Technical Bulletin

(1005326 Rev. A)

1003836 (RL-18)

Figure 1

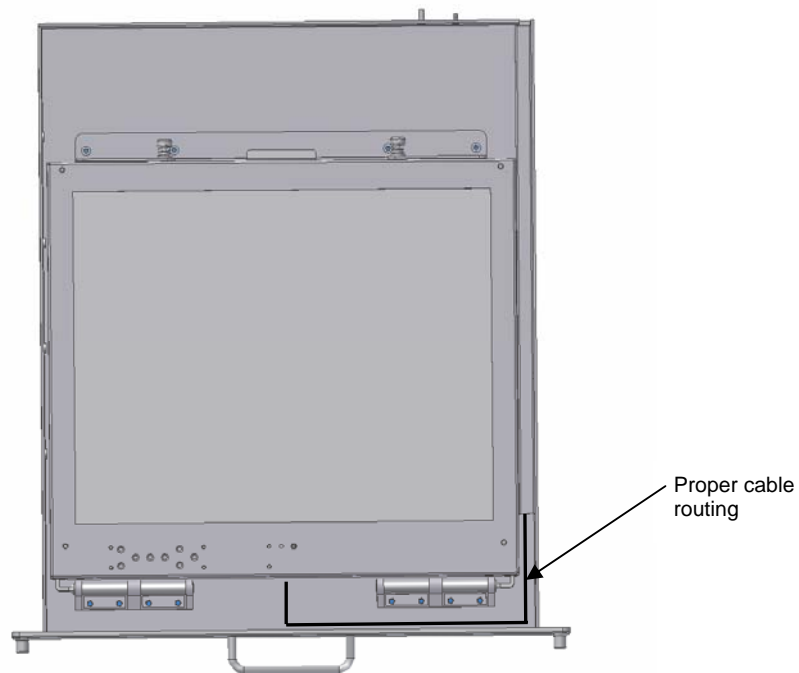
After lifting the monitor it is possible for the power & video cables to fold behind the monitor hinge. If the monitor is lowered with the cables folded behind the monitor hinge, the cables can be damaged by the monitor.

1. Before lowering the monitor ensure the cables stay as close as possible to the front and right walls of the case. Refer to figure 1 below for proper cable position.
